## PROJECT MINUTES

Project:	New Bourne Intermediate School	Project No.:	15041
Prepared by:	Joel Seeley	Meeting Date:	11/21/19
Re:	School Building Committee Meeting	Meeting No:	76
Location:	Veterans Memorial Community Center	Time:	6:30pm
Distribution:	School Building Committee Members, Attendees (MF)

Re: Evaluation of Water Leakage  
James F. Peebles Elementary School  
70 Trowbridge Road  
Bourne, Massachusetts

**Photograph 10**  
Void in field-welded seam at parapet by monitor wall above second floor classroom

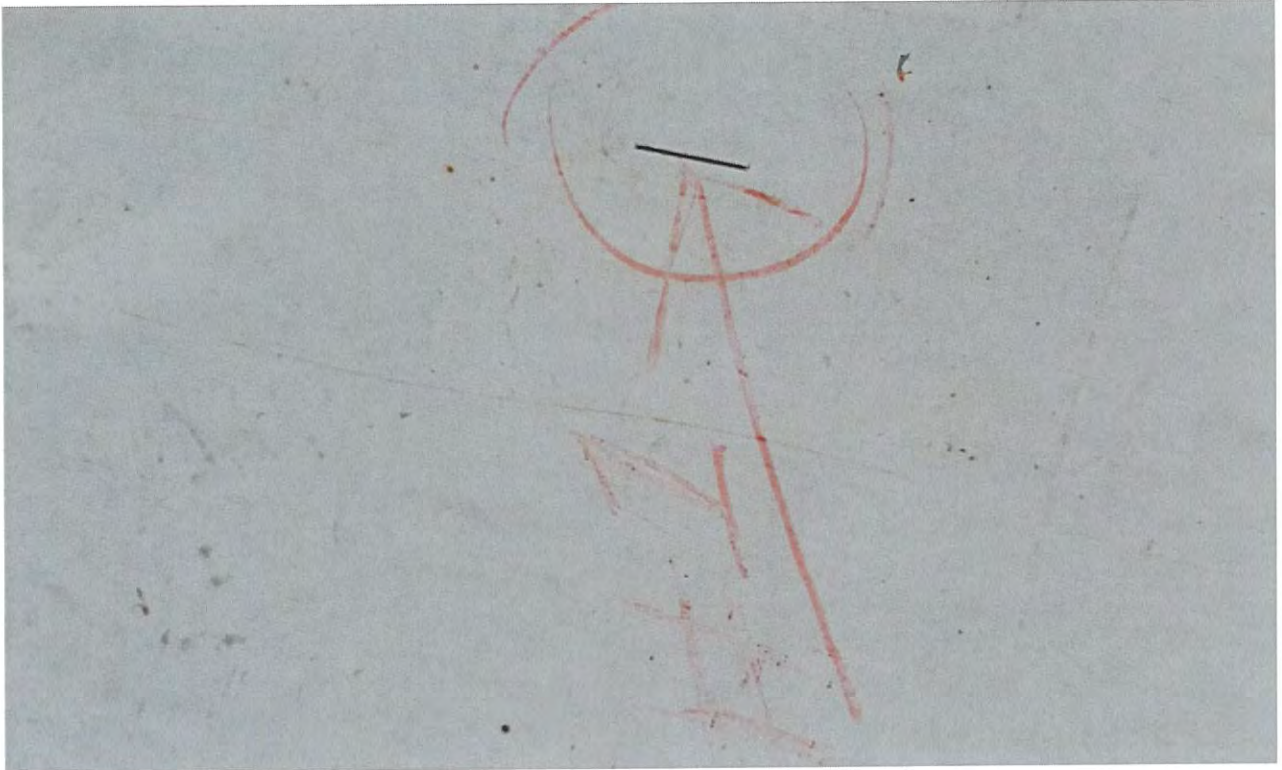
1. A void in a field-welded seam in the membrane was marked at the parapet by the monitor wall. See Photograph 10.
2. Outside of the grid by the monitor wall, a cut approximately 2 inches long by  $\frac{1}{16}$  inch wide was marked. See Photograph 11.

**Photograph 22**

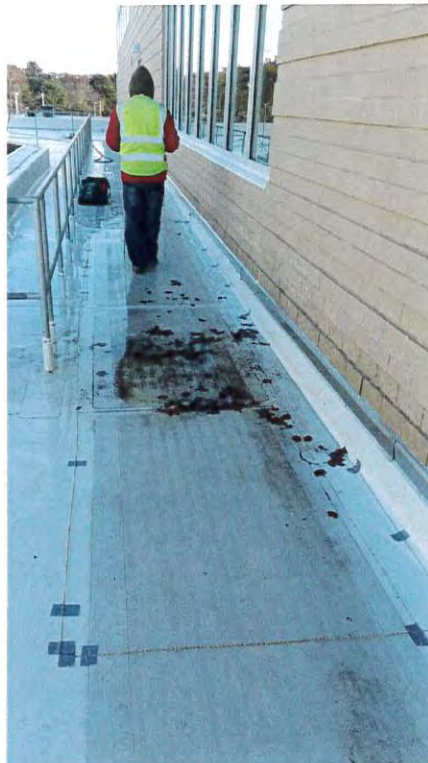
Hole in Sarnafil membrane behind a screw port in vent hood base flashing at Studio
